Service Bulletin

File name: SB0027_Digitizing_Probe_Race_Condition.pdf

Product Identification: Digitizing Probe and Mach 3

Image 1

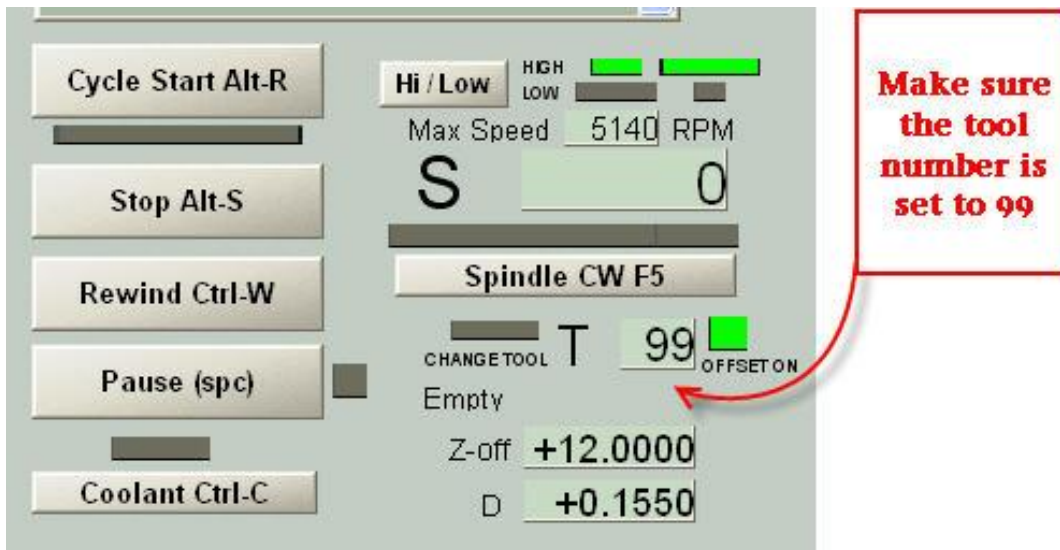
Background: When doing an X and or Y move for a probing function the Z axis can on occasion unexpectedly move as well. This issue relates to characteristics of the control computer and is caused by a race condition in Mach3. Most systems will not experience this problem.

Other Symptoms: The Mach3 authors are struggling with a variety of these race conditions. The sudden Z move seems to occur only on probing moves which need to know the tip diameter. Symmetrical operations like Find Hole Center are not affected as the routine does not have to discover the diameter of the tip from the tool table.

Remedy for problem: The suggested fix is to change the active tool number to (T99) before doing the X and or Y probe functions. See image 1 below.
